SUBJECT: **Review Comments for "Report of the Phase 1 RCRA Facility Investigation of the Mixed Waste Landfill" - SNLA**

## Comments on Phase 1 RCRA Facility Investigation of the Mixed Waste Landfill

Phase 1 RCRA Facility Investigation (RFI) for the Mixed Waste Landfill, Sandia National Laboratories, Albuquerque

# PLAN VIEW

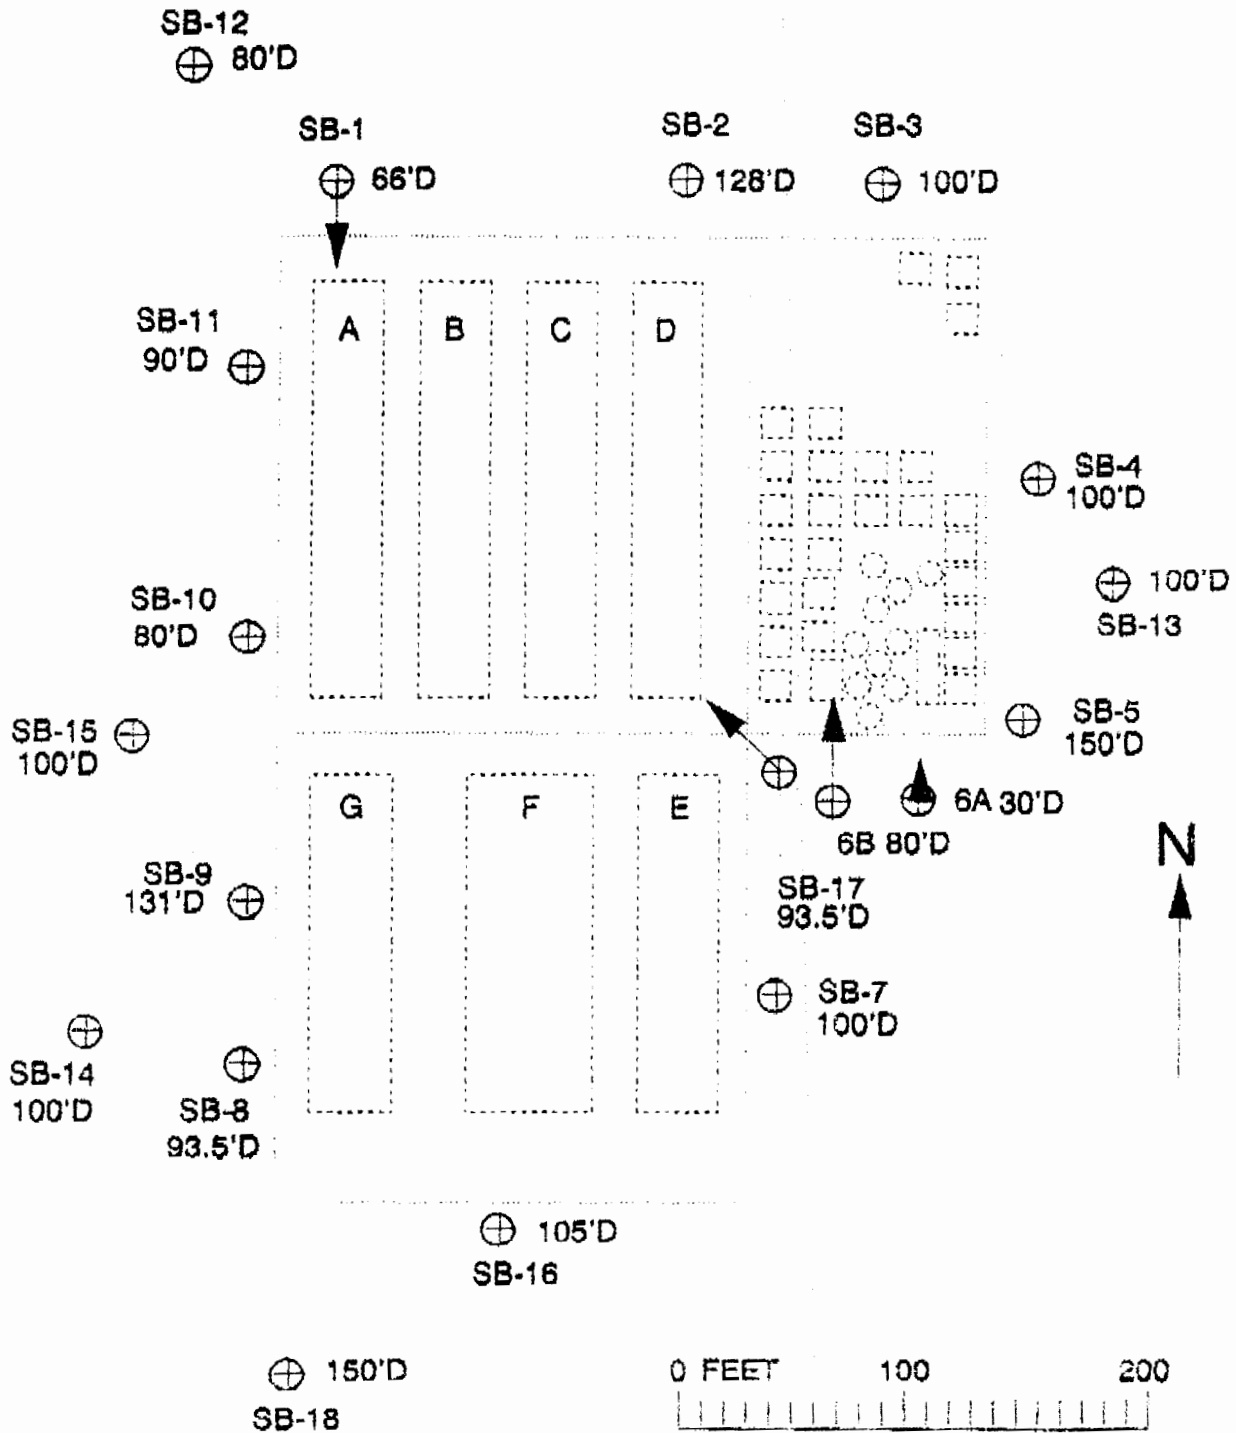
Page 2-8 The statement "In 1969, results from 10 soil cores sampled to depths of 25 to 50 feet at 5 locations around the perimeter of the MWL indicated that there was no radionuclide migration from the site." needs to be modified (e.g., change "...indicated that there was no..." to "detected no..."). Such an investigation alone is not sufficient to justify the conclusion. With only perimeter soil samples one would also have to have groundwater information showing no trace of radionuclide contamination down gradient from the site in order to ensure that the subsurface sampling had not missed a cone of contamination within the perimeter which had reached

groundwater and migrated off site below the 50 foot vertical depth of the deepest angled sample (See attached figures).

Section 6.2.1 Exposure. It cannot be concluded from the data available that the tritium contamination is "limited to the vadose zone immediately surrounding the site." The boreholes drilled do not fully characterize the potential contamination plume. As shown in the attached figures, data from the samples taken cannot rule out a cone shaped contaminant plume beneath the site which could encounter ground-water and be transported beyond the confines of the site. In addition, the areas under trenches A through G may not have been fully characterized by the samples taken. Depending on the distance to groundwater and the direction of groundwater flow, contamination could be migrating from the classified area under the caps of these trenches.

# LOOKING NORTH

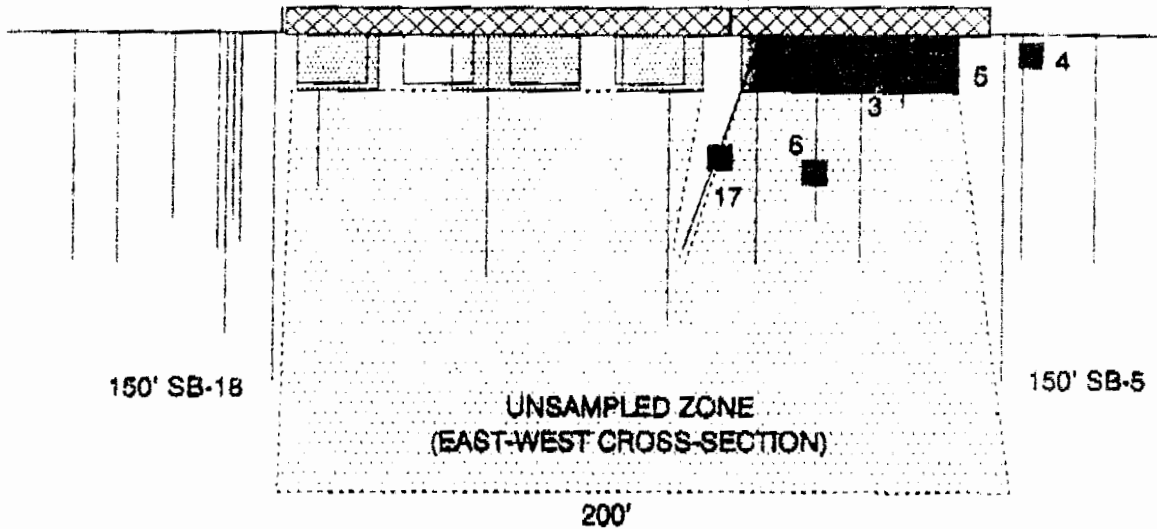
HOW DEEP IS THE WATER TABLE?

# LOOKING EAST

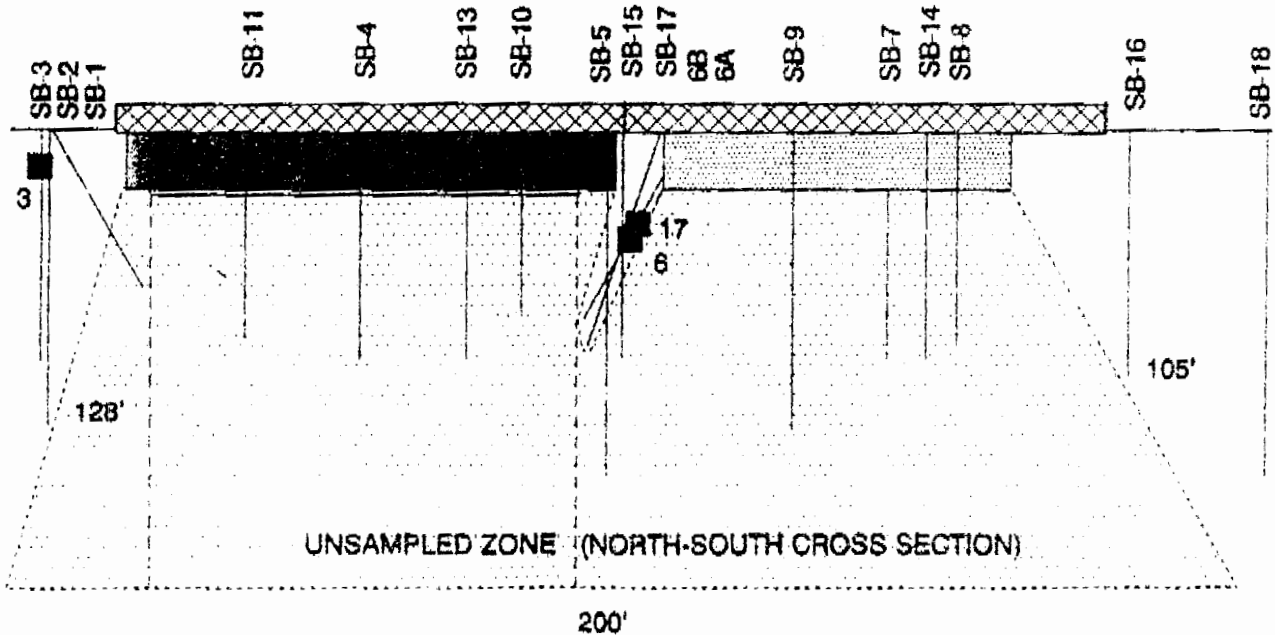
HOW DEEP IS THE WATER TABLE?
